DOCKETED			
Docket Number:	18-BSTD-03		
Project Title:	2019 Energy Code Data Registry Requirements Manual		
TN #:	227222		
Document Title:	SolarEdge Technologies Comments Residential and Nonresidential Alternative Calculation Method Reference Manuals and Compliance Software Tools		
Description:	N/A		
Filer:	System		
Organization:	SolarEdge Technologies		
Submitter Role:	Role: Public		
Submission Date:	3/1/2019 2:50:24 PM		
Docketed Date:	3/1/2019

Comment Received From: SolarEdge Technologies

## 2019 RESIDENTIAL ALTERNATIVE CALCULATION METHOD REFERENCE MANUAL AND COMPLIANCE SOFTWARE TOOLS

Figure 1 – Energy Design Rating slide from Residential ACM Workshop Presentation

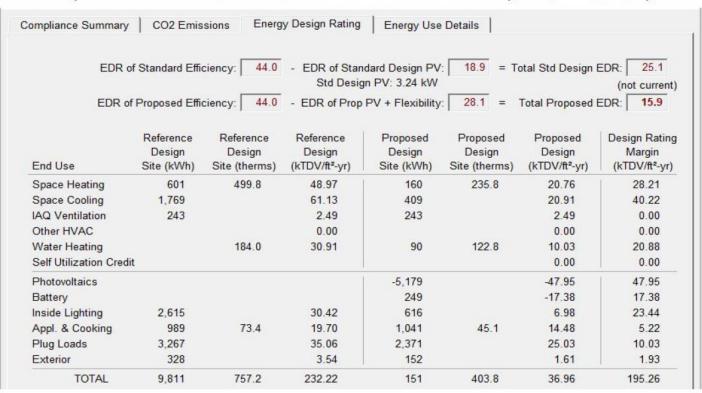
Please refer to slide shown in Figure 1 below that was shared at the Residential ACM workshop conducted by CEC on February 14, 2019. It was mentioned that roughly 3 EDR points could be traded off with Efficiency EDR, with 9.2 point difference between 28.1 (Prop. PV + Flexibility) and 18.9 (Std. PV). Can you please include more detailed example(s) explaining how many trade-able EDR points are equivalent to the difference between Prop. PV + Flexibility and Std. Design?
8	EDR Tradeoff with electric water heater	Requesting CEC to elaborate if diverting excess PV to electric water heater is acceptable. And elaborate on amount of EDR score that can be traded off with other efficiency features when electric water heater is installed.
